G.L. LONG SECOND ADDITION WICHITA, KANSAS

FINAL PLAT

Re: S/D 90-53 (Final Plat) G.L. Long Second Addition

CASE NUMBER: S/D 90-53 - G.L. LONG SECOND ADDITION

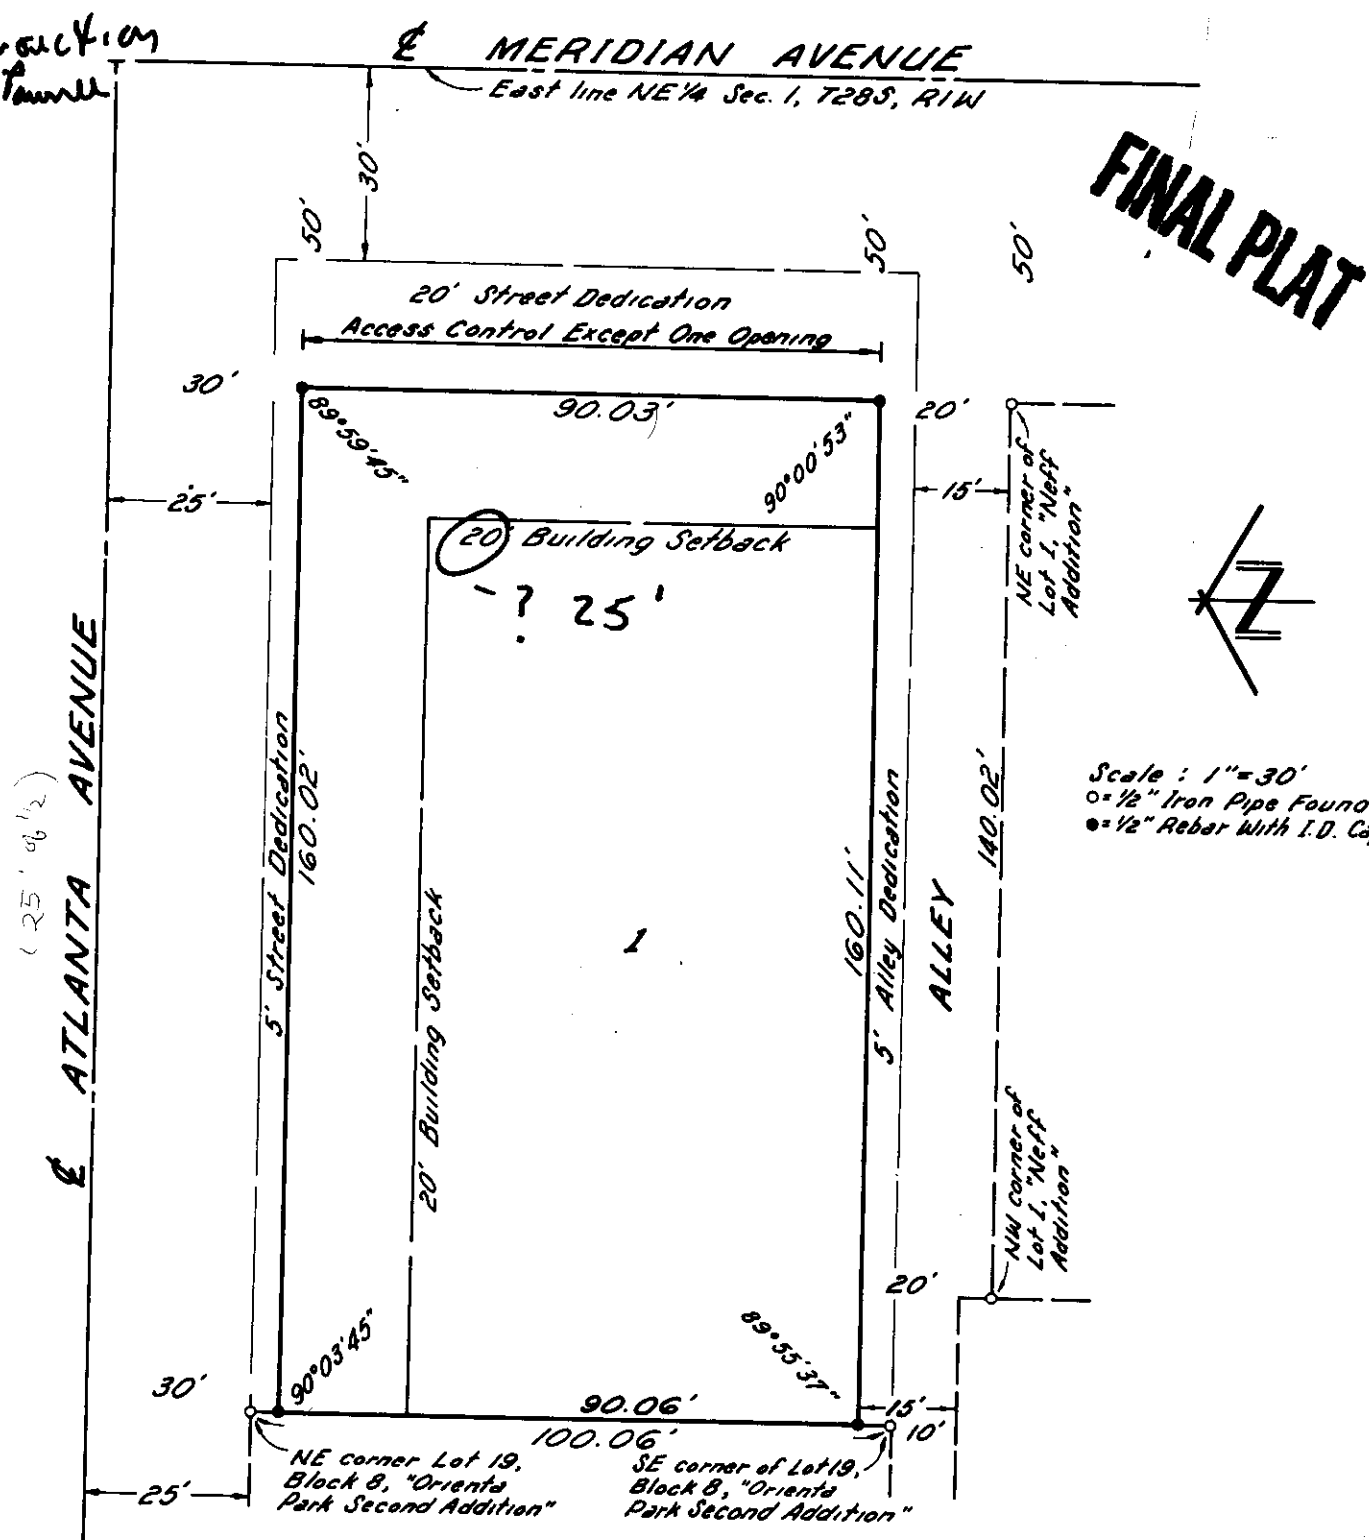
- A. Approval of this plat is subject to approval of the applicant's associated zone case (Z-3005) and any conditions of that approval.
- B. The final plat tracing shall indicate the platting of a 35 foot front yard building setback off of Meridian and a 20 foot side yard building setback off Atlanta.
- C. The applicant shall install or guarantee the installation of all utilities and facilities which are applicable and described in Article 8 of the MAPC Subdivision Regulations.
- D. The applicant's engineer is advised that the Register of Deeds is requiring the name(s) of the notary public, who acknowledges the signatures on this plat, to be printed beneath the notary's signature.
- E. Perimeter closure computations shall be submitted with the final plat tracing. Section 5-101(c).
- F. Recording of the plat within 30 days after approval by the City Council.
